CCB 8000
Pre and Post Change Summary
PCN #: MFOL-22GSIN584

Pre and Post Change Summary – T/R (Carrier Tape)

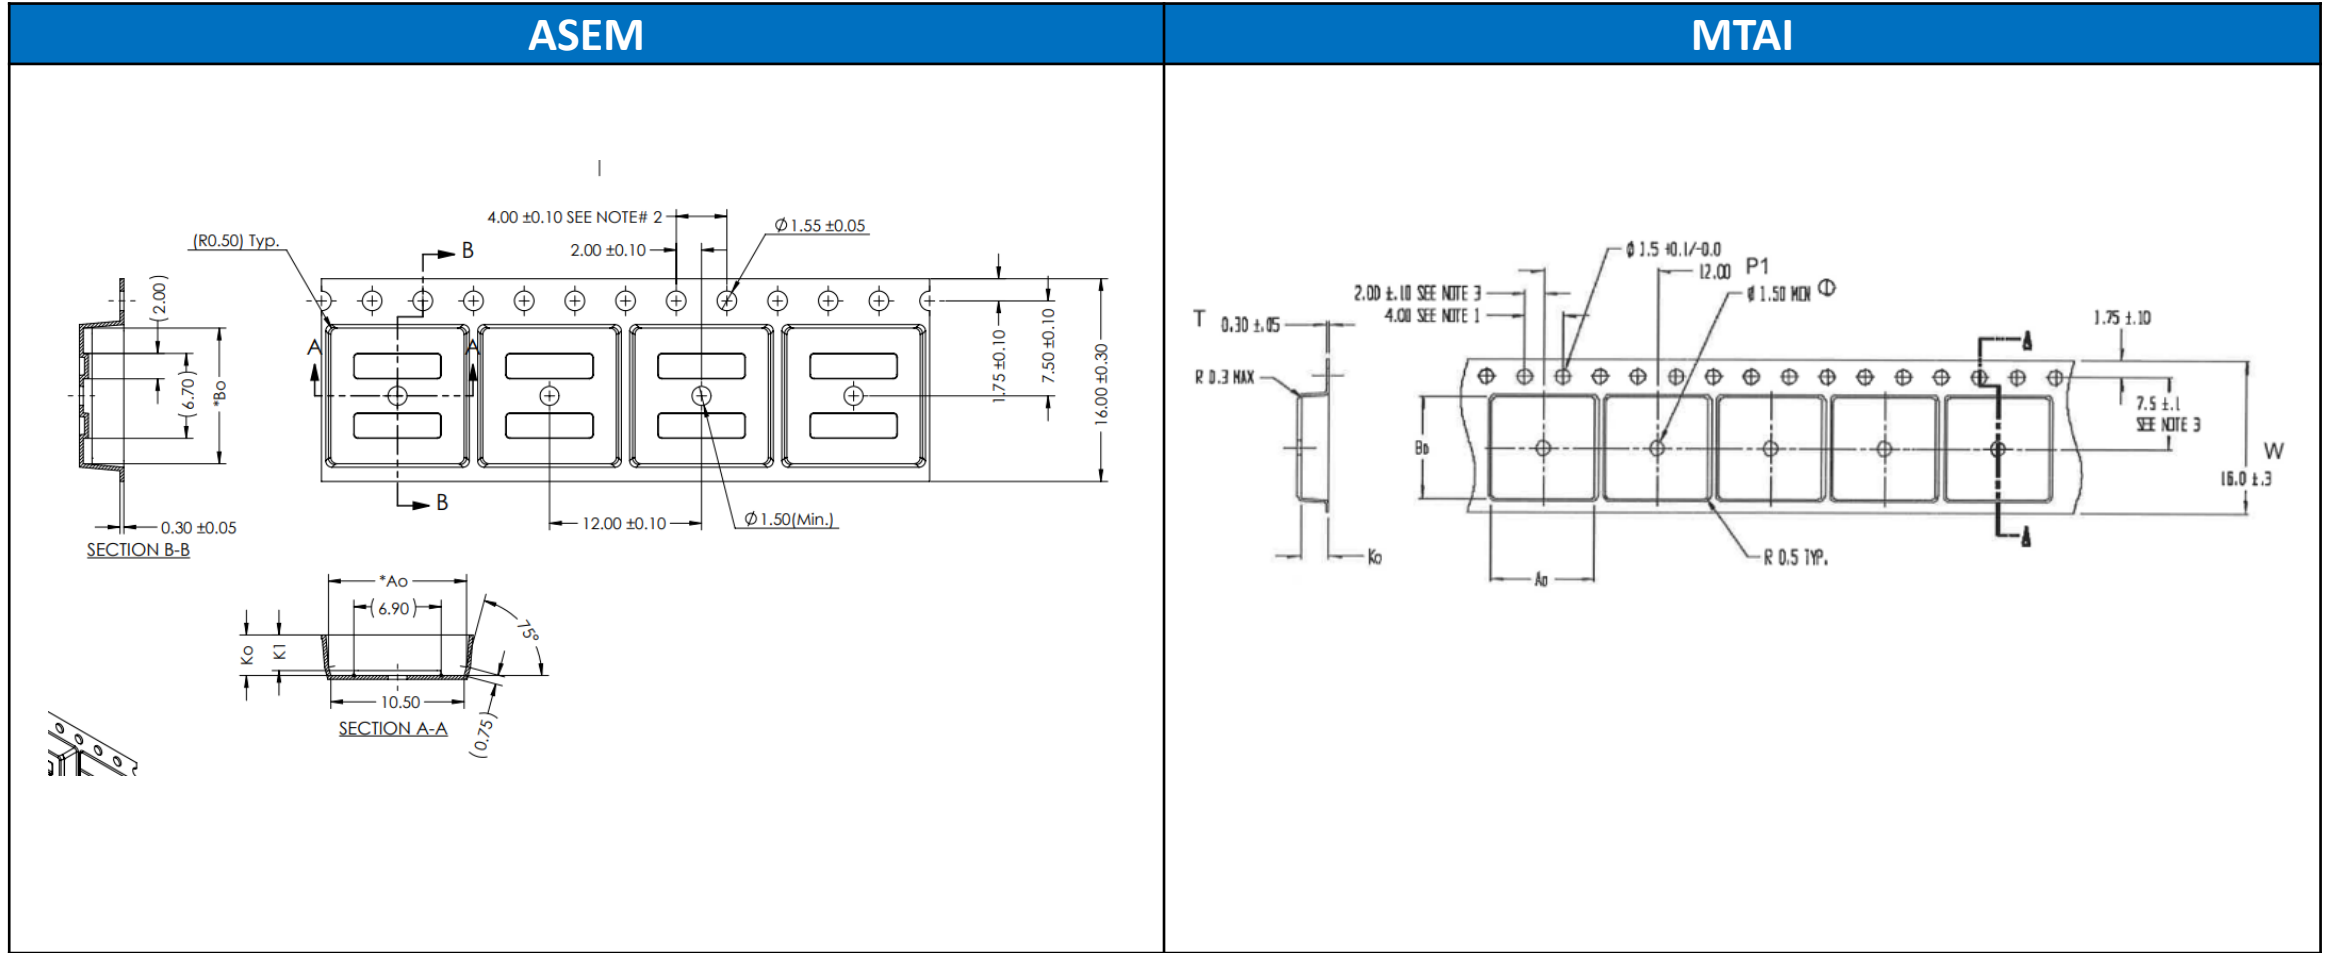
Plant	W (mm)	P (mm)	A0 (mm)	B0 (mm)	K0 (mm)	K1 (mm)	Thickness (mm)
ASEM	16.00 ± 0.30	12.00 ± 0.10	10.90 ± 0.10	10.70 ± 0.10	3.20 ± 0.10	2.80 ± 0.10	0.3 ± 0.05
MTAI	16.00 ± 0.3	12.00 ± 0.1	10.90 ± 0.1	10.70 ± 0.1	3.00 ± 0.1	-	0.30 ± 0.05

Pre and Post Change Summary – T/R (Cover Tape)

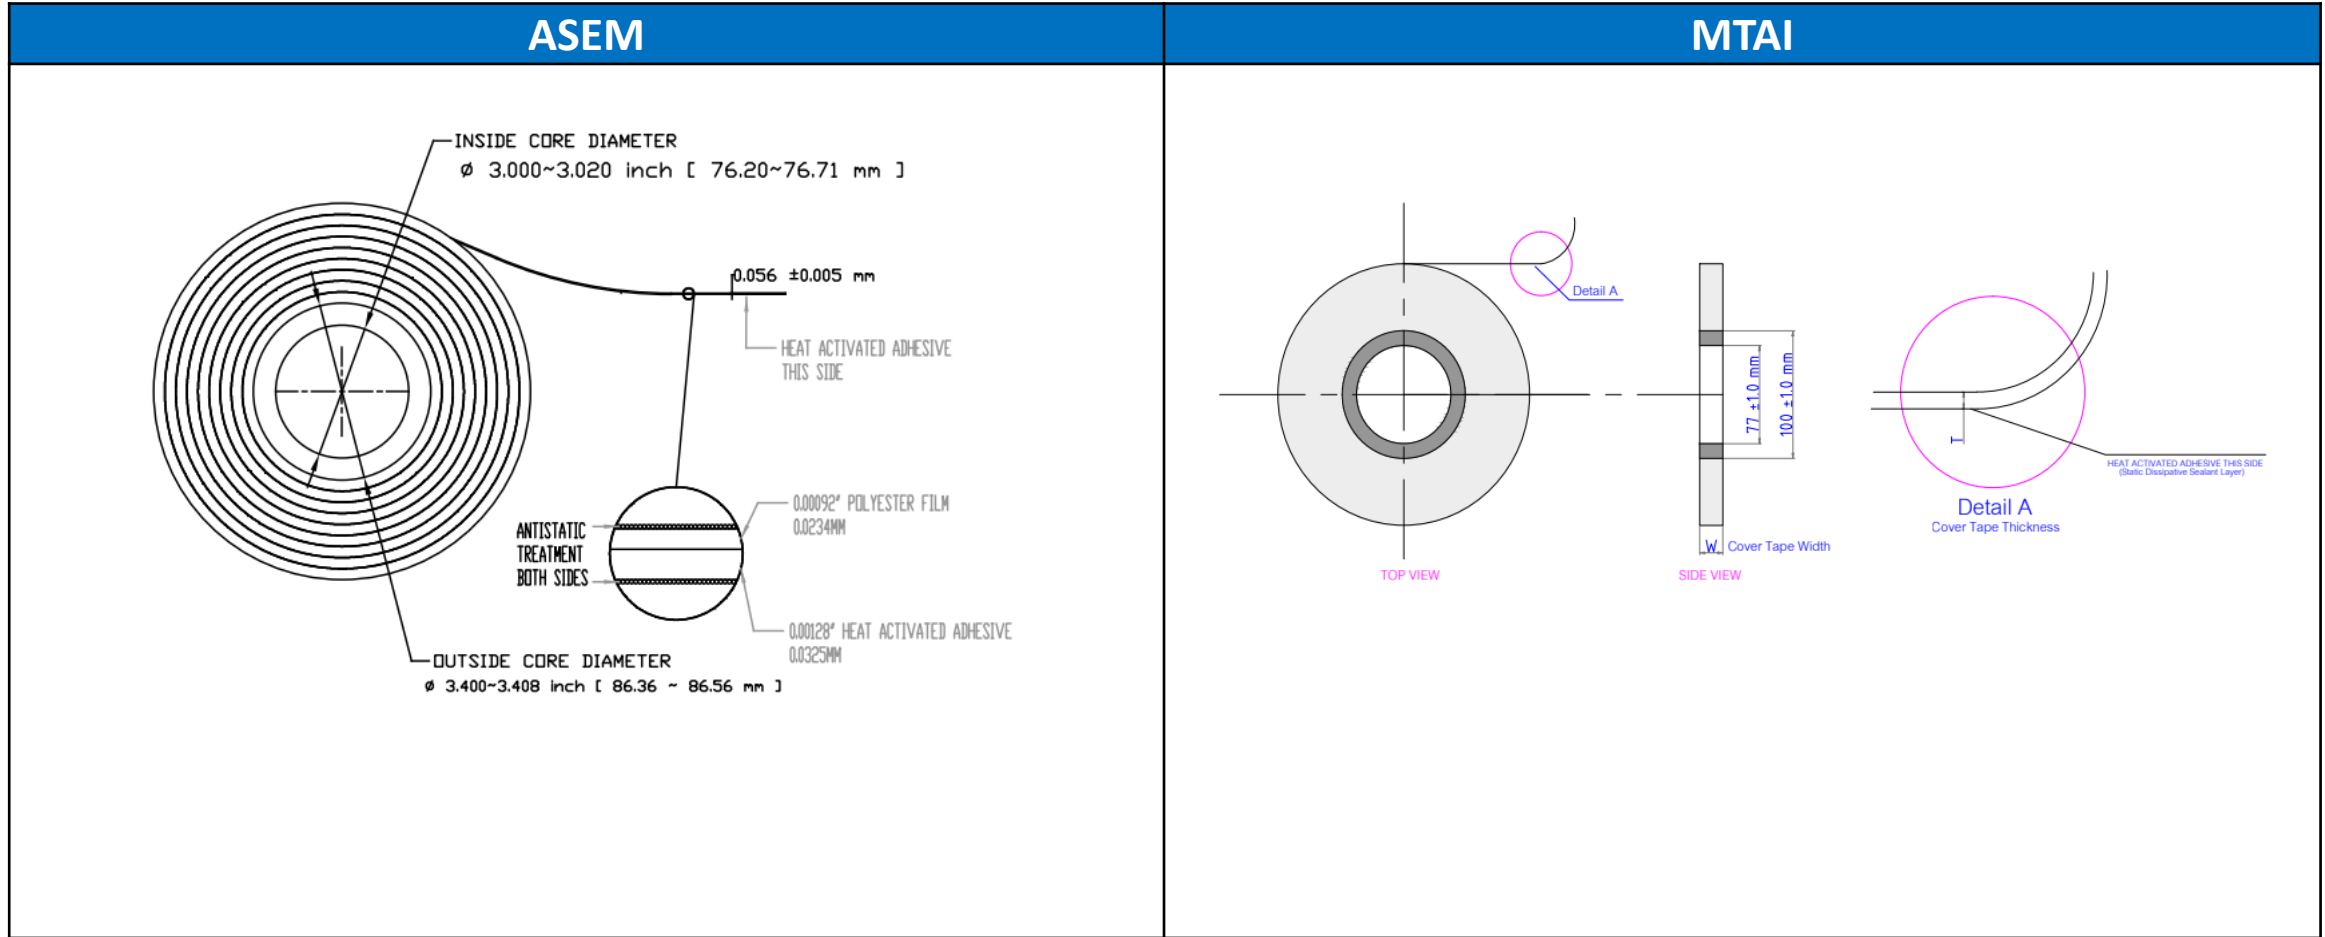
Plant	Width W (mm)	Thickness T (mm)	Color	Sealing Methodology
ASEM	13.3 ± 0.1	0.056 ± 0.005	Clear	Heat sealing
MTAI	13.3 ± 0.1	0.050 ± 0.010	Clear	Heat sealing

Pre and Post Change Summary – T/R (Static Shielding Bag)

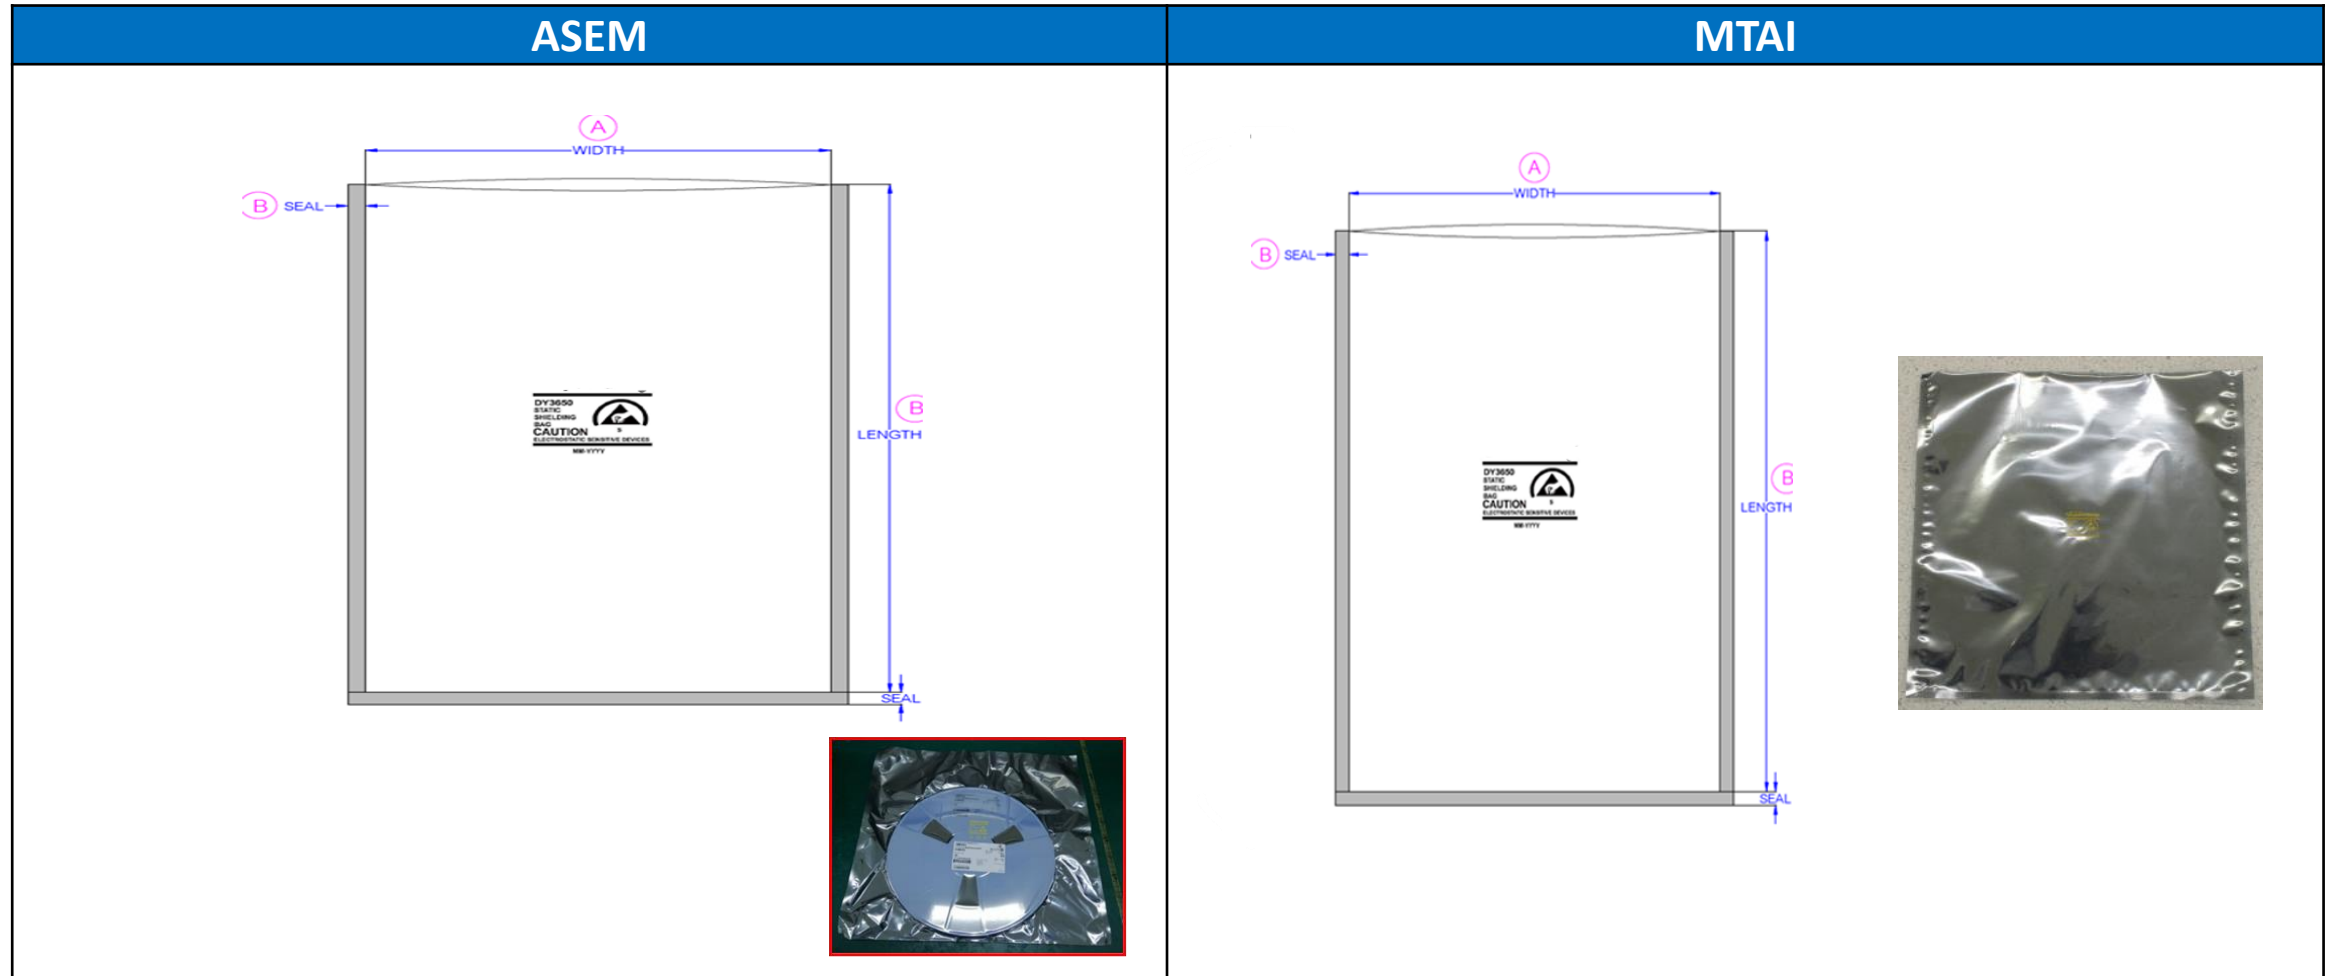
Plant	Bag type	Length (mm)	Width (mm)	Thickness (mm)
ASEM	Static Shielding Bag	457±5.00	457±5.00	0.0762
MTAI	Static Shielding Bag	420 +5/-0	370 +5/-0	0.0762

Pre and Post Change Summary – Tube

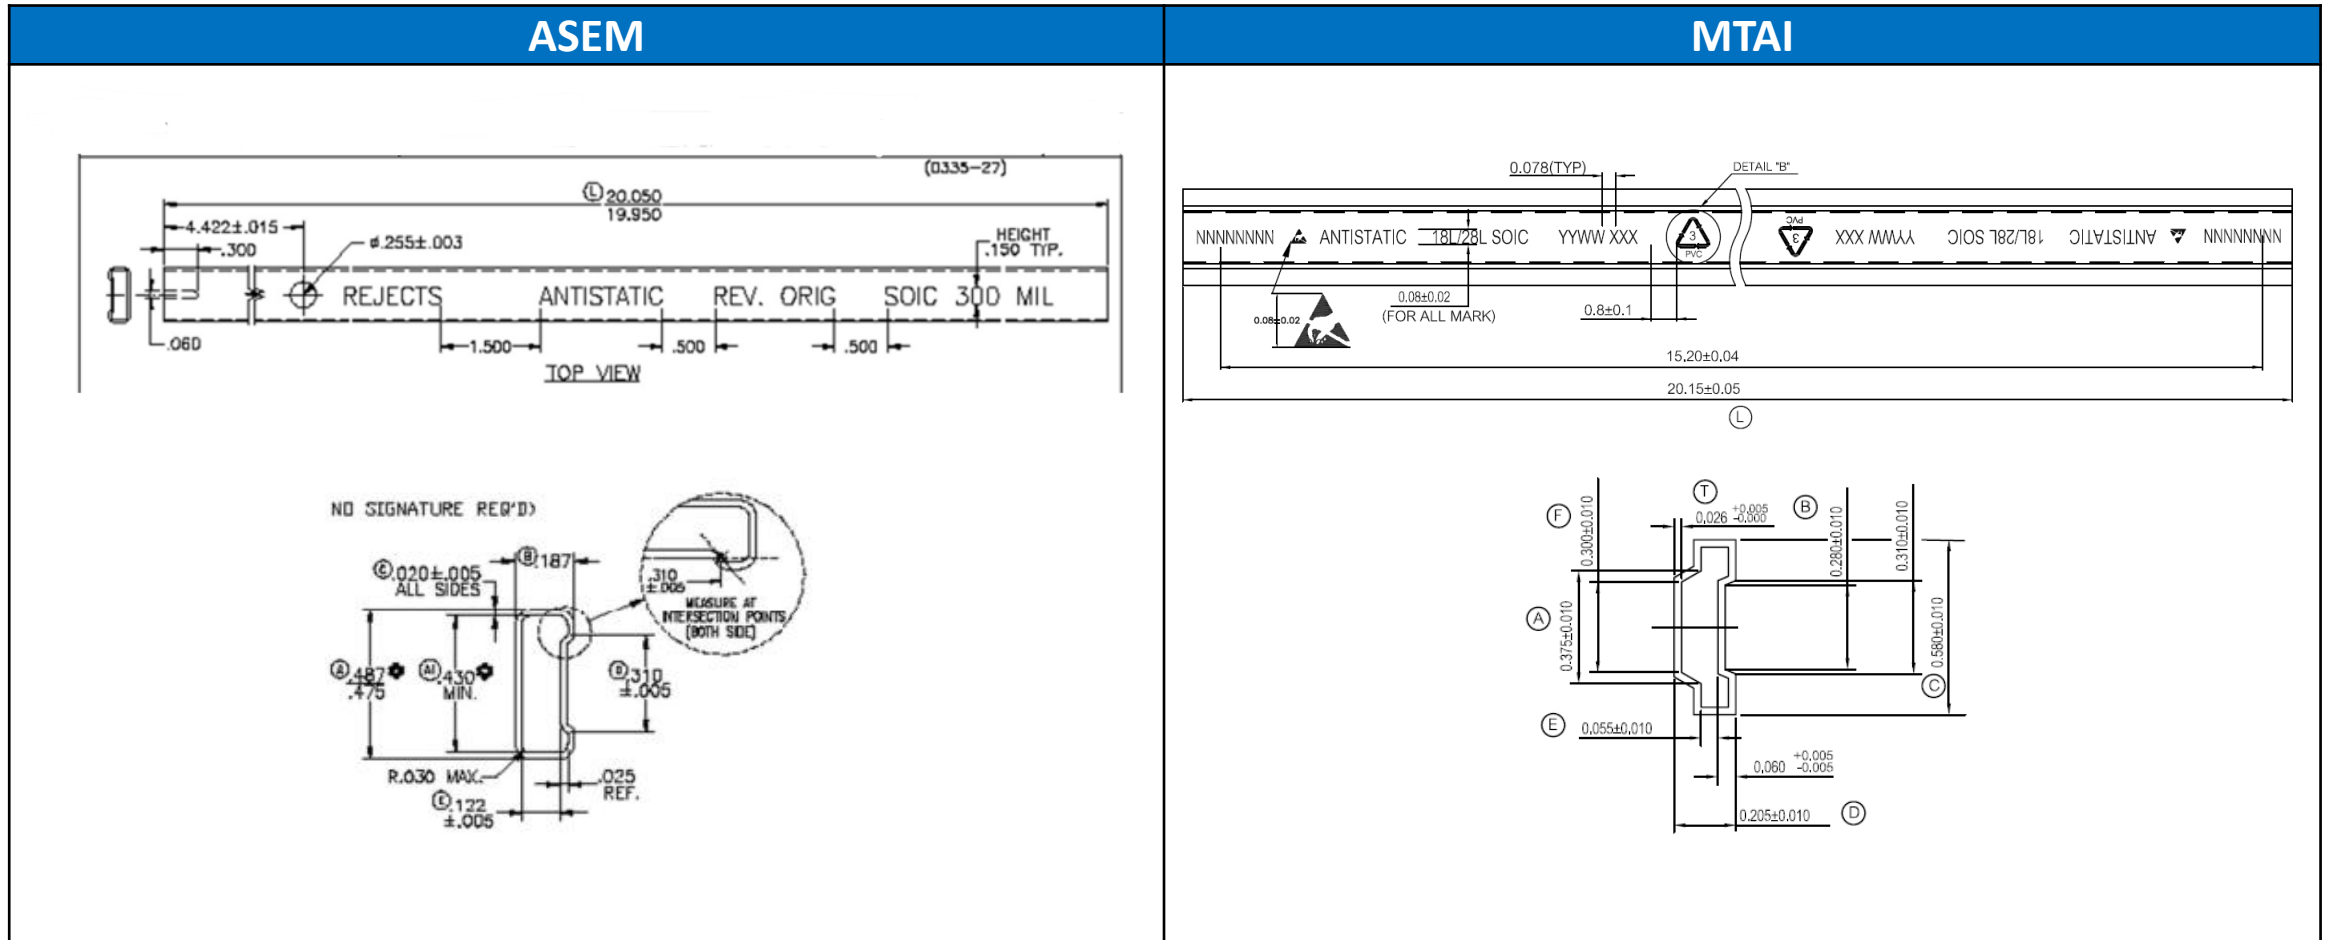
Plant	Tube Length (inch)	Dimension	Tube Color	Unit per Tube	Tubes per Bag
ASEM	20.00 ±0.05	See on drawing	Clear	46	25
MTAI	20.15 ±0.05	See on drawing	Clear	46	40

Note: The standard MTAI packing is 47 units per tube. The quantity per tube shown in the table above will support MASK: 1H001, 1H002, 1H010, 1H013, 1H015, V8013, V8014, V8015, V8016, V8031 transfer to MTAI only.

Pre and Post Change Summary – Tube (Pin 1 Orientation)

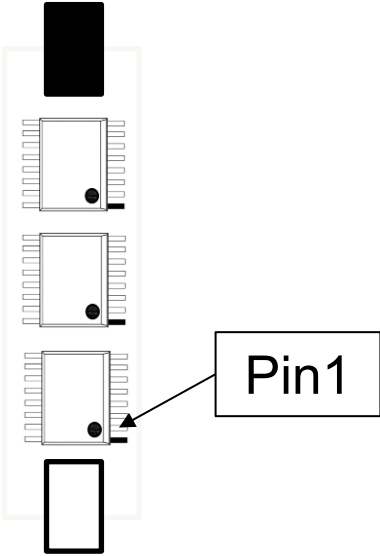
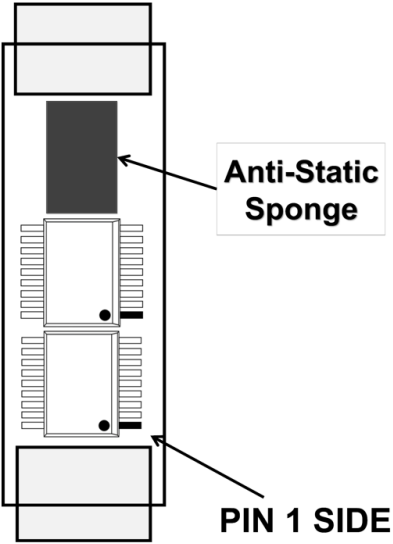
Media	Pin1 Side Color	Opposite Side Color	Media	Pin1 Side Color	Opposite Side Color
Plug	White	Black	Plug	White	Black
